# Access Compliance Report

## Public Rights-of-Way

Intersection ID: 11481	Main Street: AFTON_LN	Cross Street: THORNTON_RD	Location: SW
ADA ID: 6A311571DE5B	Ramp Type: Perp	Initial Pass/Fail: Fail	Overall Compliance: No
Severity Score: 33.75			
Codes/Mitigation Info/Possible Solution		Field Measurements/Component Compliance

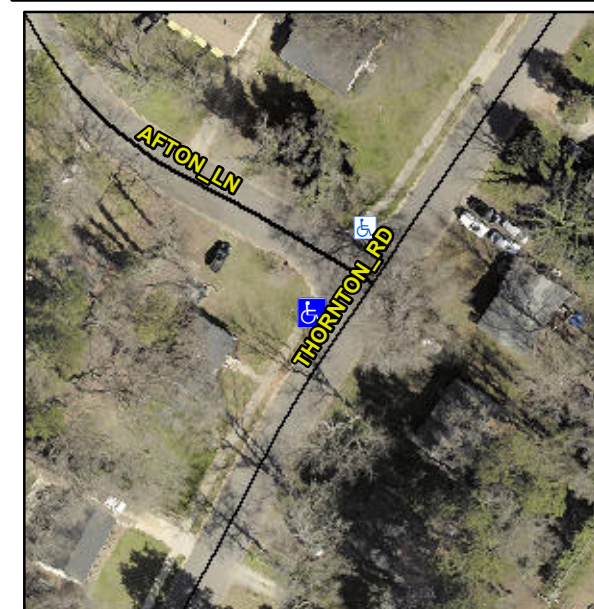
**Not Found, R304.5.1, R304.5.3**

Compliance	Description	Data	Compliance	Description	Data
N/A	Ramp Length (in)	49.5	Yes	Ramp Slope (%)	6.8
No	Ramp Width (in)	47.0	No	Ramp XSlope (%)	8.3
N/A	Flare Type LT	N/A	N/A	Flare Type RT	N/A
N/A	Flare Slope LT (%)	N/A	N/A	Flare Slope RT (%)	N/A
N/A	Flare Traversable LT?	N/A	N/A	Flare Traversable RT?	N/A
N/A	Landing Length (in)	N/A	N/A	DWS Provided?	N/A
N/A	Landing Width (in)	N/A	N/A	DWS Contrast?	N/A
N/A	Landing Slope (%)	N/A	N/A	DWS Length (in)	N/A
N/A	Landing X Slope (%)	N/A	N/A	DWS Full Width?	N/A
N/A	Landing Curb? (Y/N)	N/A	N/A	DWS Offset (in)	N/A
N/A	Shared Landing?	N/A			
N/A	Gutter Ponding?	N/A	N/A	Gutter Slope (%)	N/A
N/A	Gutter Lip Ht (in)	N/A	N/A	Gutter X Slope (%)	N/A
N/A	Painted X Walk1?	No	N/A	Painted X Walk2?	N/A
	X Walk 1 Direction	To NE		X Walk 2 Direction	N/A
N/A	X Walk 1 Width (in)	N/A	N/A	X Walk 2 Width (in)	N/A
	X Walk 1 Slope (%)	6.1		X Walk 2 Slope (%)	N/A
	X Walk 1 X Slope (%)	3.1		X Walk 2 X Slope (%)	N/A

**Remove & Replace Entire Ramp.**
